PROPOSED TECHNICAL SPECIFICATION CHANGE

SURREY POWER STATION
ORGANIZATION CHART

DISCUSSION OF PROPOSED TECHNICAL SPECIFICATION CHANGE

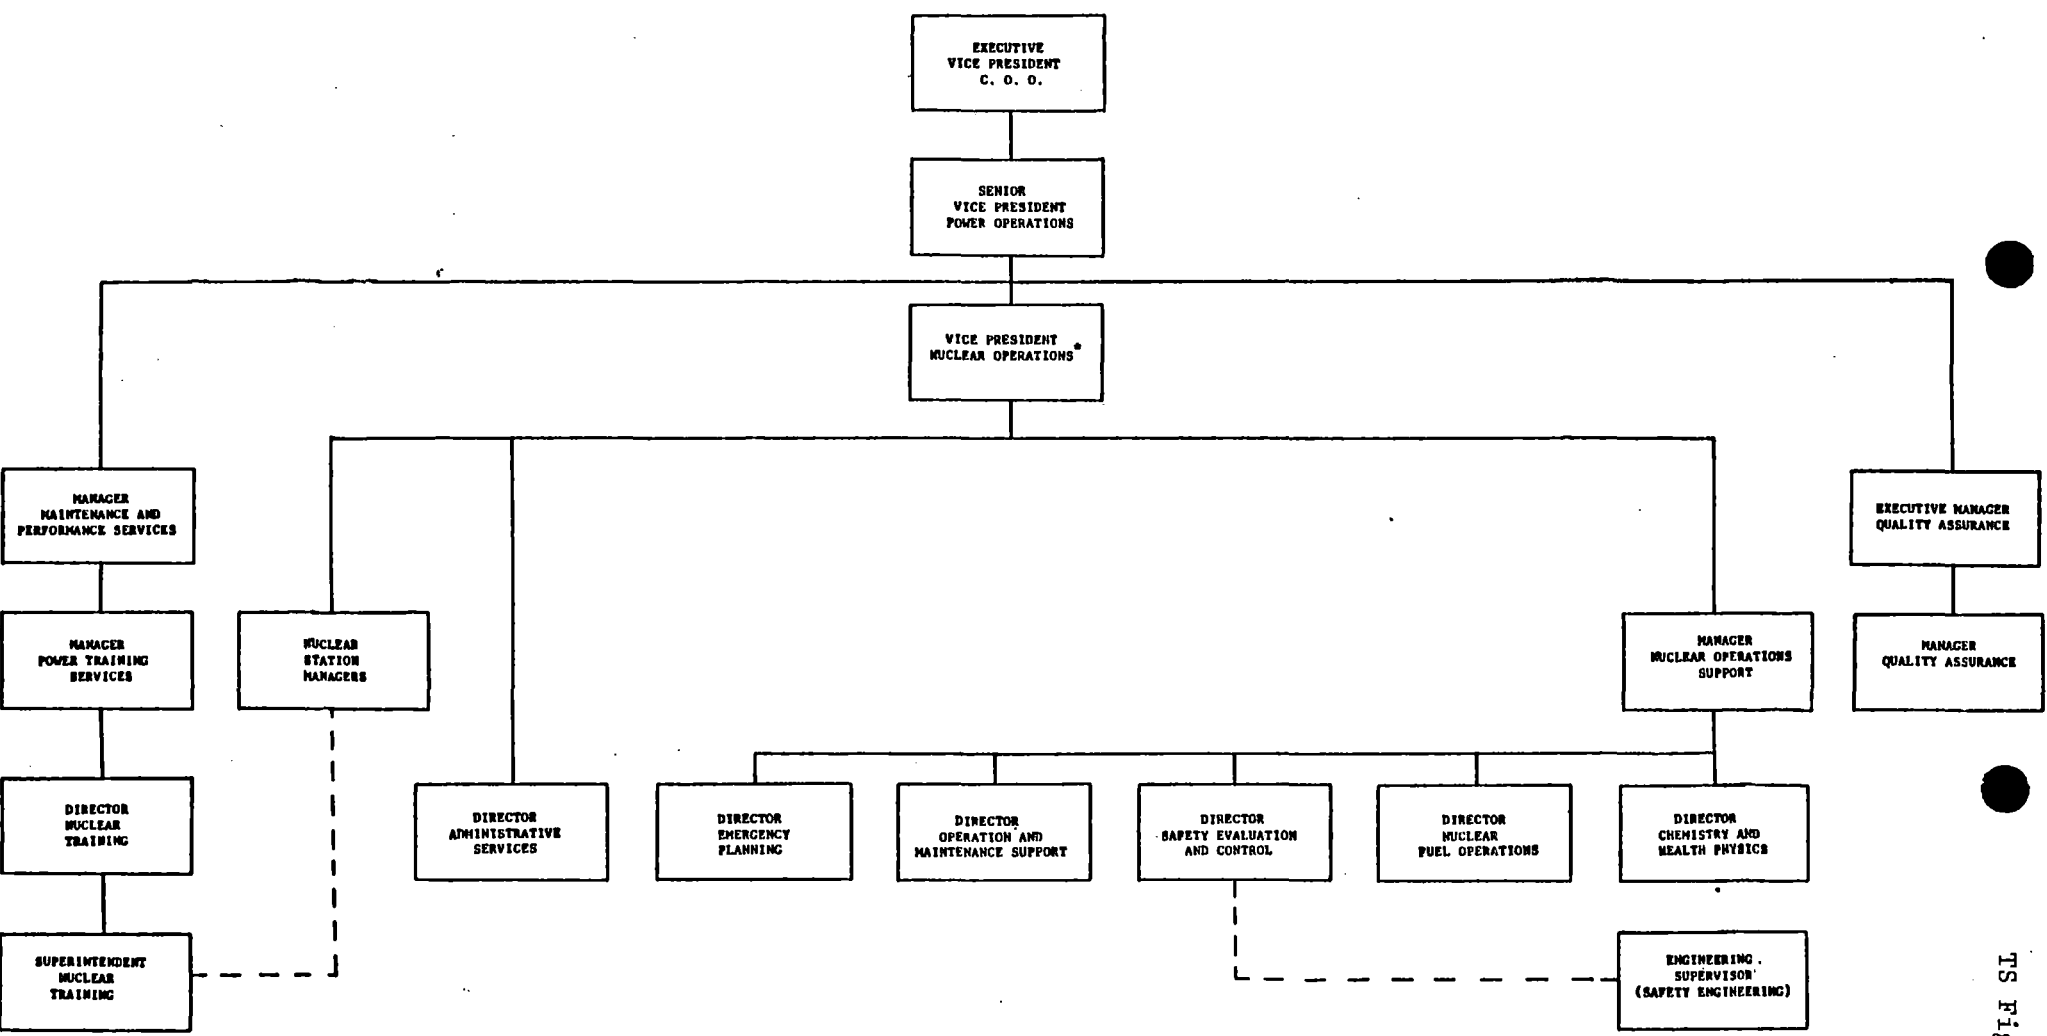
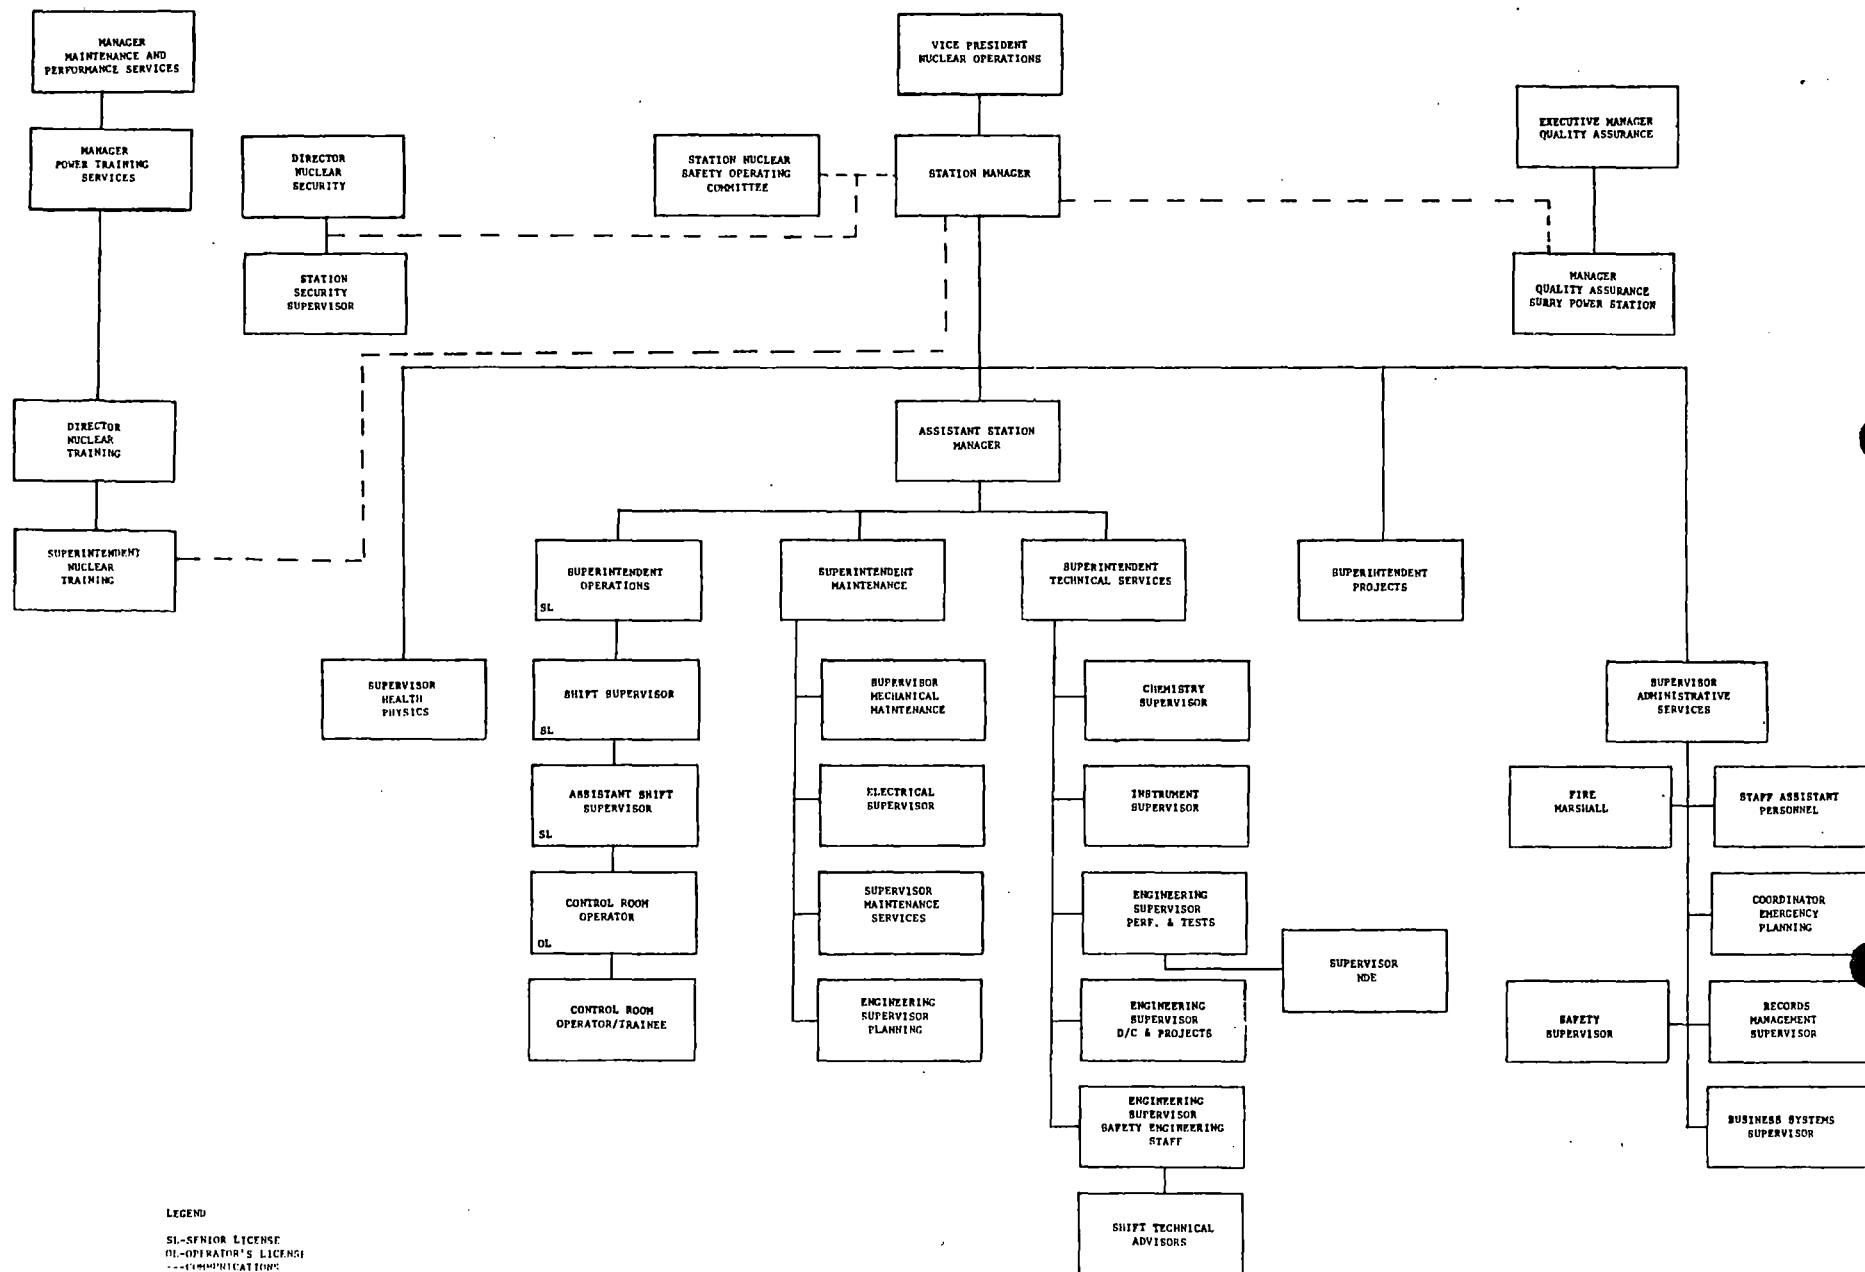
The proposed Technical Specification changes reflect the recent reorganizations within the Nuclear Operations Department and Maintenance and Performance Services Department.

The reorganization within the Nuclear Operations Department and the Maintenance and Performance Services Department will aid in the quality of training activities at the power stations. The Director Training within the Nuclear Operations Department will now be the Director Nuclear Training in the Maintenance and Performance Services Department. The Director Nuclear Training will report to the Manager Power Training Services who will report to the Manager Maintenance and Performance Services who will ultimately report to the Senior Vice President Power Operations. The Director Nuclear Training will have the Superintendent Nuclear Training (who is located at the power station) reporting directly to him. The Superintendent Nuclear Training will have communications with the Station Manager.

The Director Nuclear Training will continue to plan, organize, direct and control nuclear training, so that effective and efficient technical training is provided to Nuclear Operations. The Director Nuclear Training will assess and recommend specific training requirements for regulatory agencies as applicable and coordinate programs offerings as necessary.
